2015/3709/P – 17 – 79 Mansfield Road

Delegated Report (Members Briefing)		Analysis sheet	Expiry Date:	03/12/2015
		N/A	Consultation Expiry Date:	30/12/2015
Officer			Application Number	
Anna Roe			2015/3709/P	
Application Address			Drawing Numbers	
17-79 Mansfield Road, London, NW3 2JE			Please refer to decision notice.	
PO 3/4	Area Team Signature	C&UD	Authorised Officer Signature	
Proposal				
Replacement of all existing windows with double glazed timber framed windows.				
Recommendation:	Grant Planning Permission			
Application Type:	Councils Own Permission Under Regulation 3

Replacement of all existing windows with double glazed timber framed windows.

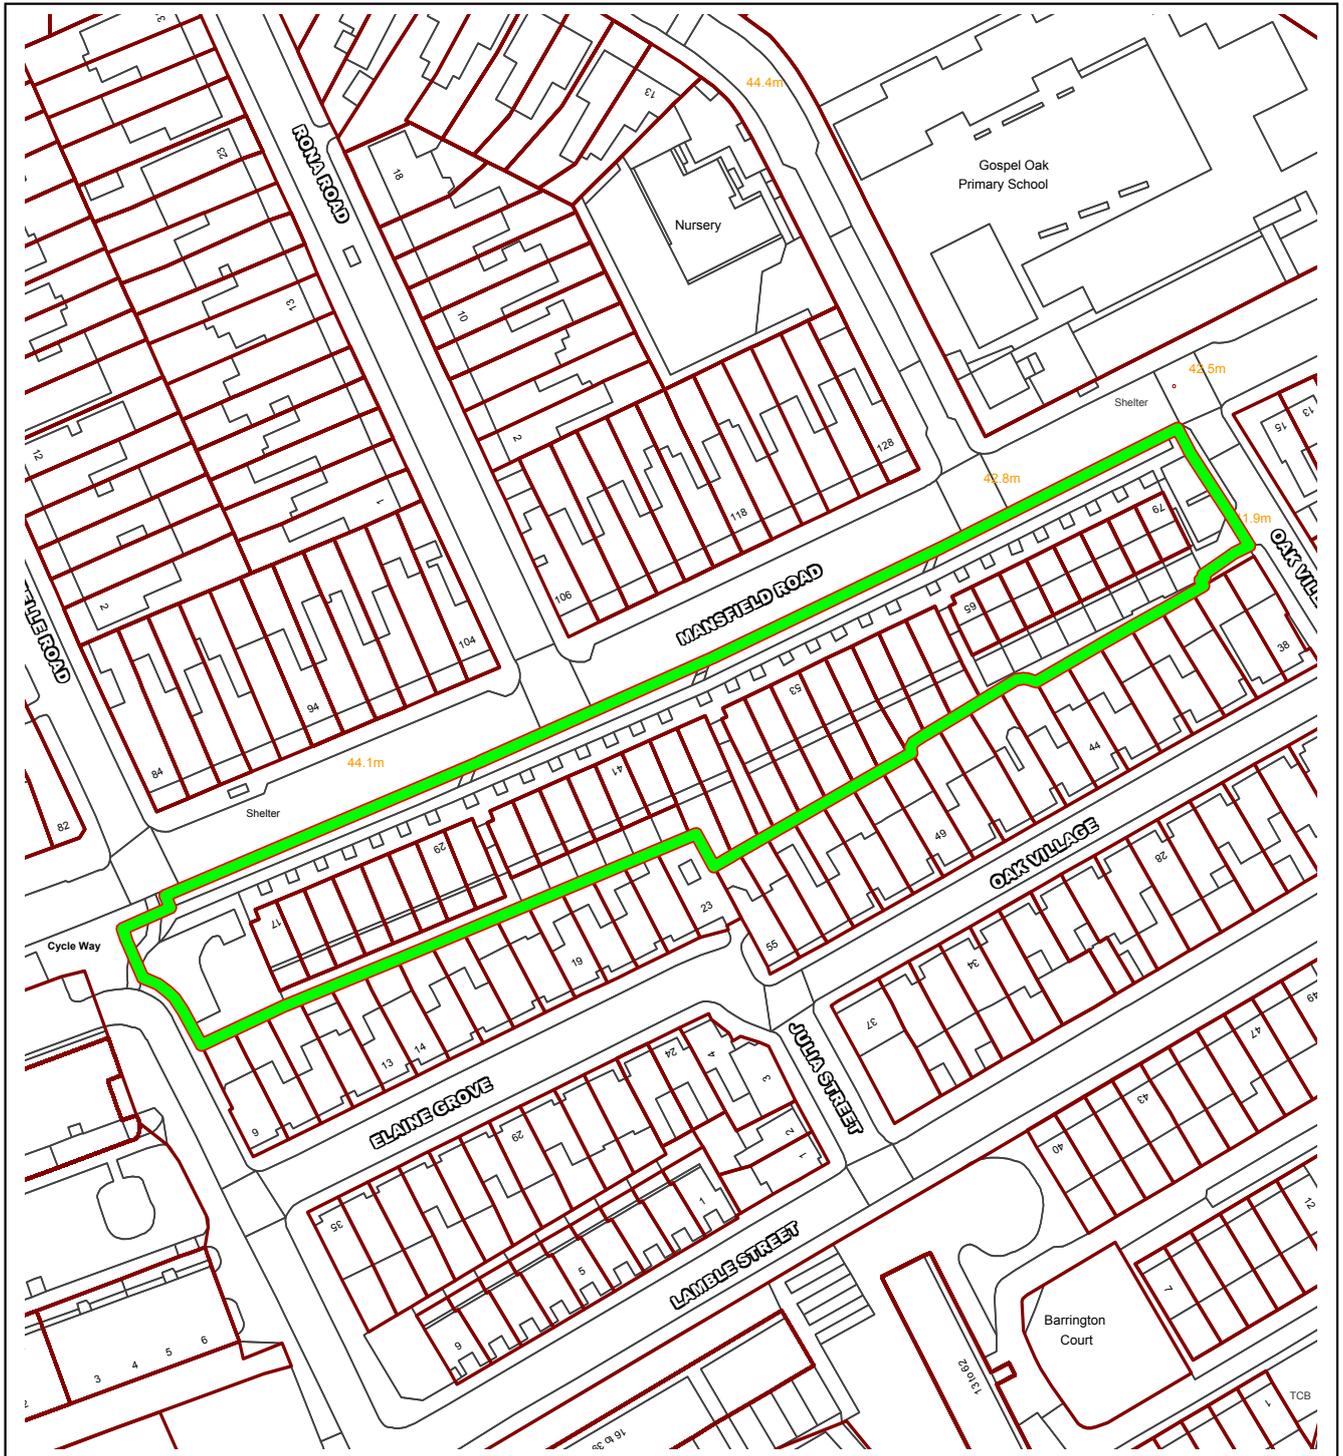
Conditions:	Refer to Draft Decision Notice					
Informatives:						
Consultations						
Adjoining Occupiers:	No. notified	130	No. of responses	36	No. of objections	23
			No. electronic	00		
Summary of consultation responses:	<p>Initial advertisement in Ham & High 16/07/15, expired 06/08/15.</p> <p>Initial site notice displayed 23/07/15, expired 13/08/15.</p> <p>Second advertisement in Ham & High 15/10/2015, expired 05/11/2015</p> <p>Second site notice displayed 14/10/2015 – 04/11/2015</p> <p>Second consultation period 28/10/2015 – 11/11/2015</p> <p>Third consultation period 15/12/2015 – 29/12/2015</p> <p><i>The proposal was revised three times due to inaccuracies on the existing and proposed plans and changes in the scope of the proposed works. The proposal was also revised at the request of officers and in response to residents' concerns.</i></p> <p><u>Materials</u></p> <ol style="list-style-type: none"> 1. I am disturbed by the fact that you plan to replace the windows with poor quality soft wood. We would welcome something of quality either hardwood or preferably metal. <p><u>Design</u></p> <ol style="list-style-type: none"> 2. I am concerned that the windows will not be replaced with exact replicas and that alteration to the sight lines and frames will detract from the overall character of the building. Exact replicas should be provided. 3. Type A/B proposed windows (from kitchen onto red walkway). The proposed drawings suggest replacing the existing solid hinged panel with a fixed panel. The existing small solid hinged panel provides valuable speedy ventilation to the kitchen as it is at an accessible height from inside. We object to this window being replaced with a fixed panel. 4. Proposed window types F and G have a different structural opening to the existing and therefore would not work. 5. The existing type H drawings are dimensionally incorrect both in height and width. As such the existing is wrong and the proposals are not as per the true existing and as such this is unacceptable. On all of the above, we would note that the structural openings cannot be changed and as such the inaccuracies are very concerning. 6. Proposed window type J omits the split door in favour of a single

door. I oppose this as it changes the design significantly.

7. Proposed window type M (sliding doors) does not have the existing opening vents and are shown as a fixed panel. The opening panels are key to the original designs and provide an important and secure source of ventilation to the bedrooms (A flats) and living areas (B flats). In addition the whole proportion of the fixed glazed panel is shown differently to the existing. The proposed doors slide internally rather than externally and changing this will cause issues with internal linings/built in original furniture etc.

8. Type O, I object to the vent panel in this window being replaced with a fixed panel. It is not as per the original design and it would be ridiculous to remove ventilation.

6. Some details such as the split door would be impractical to reproduce on what is not a listed building. This is not considered to significantly alter the character or visual appearance of the building.

7. Existing window types M (sliding doors) has an opening vent of which some are part fixed and some are full length opening down to ground level. Proposed window type M would have a part fixed opening vent to allow bedrooms to be safely ventilated. The proposed type M window would slide on the inside of the frame, to accord with secure by design guidance. The proposed glass panel is wider than the existing; however again this is not considered to significantly alter the character or appearance of the building.

8. Details such as the ventilation panels would be impractical to reproduce on what is not a listed building. This is not considered to significantly alter the character or appearance of the building.
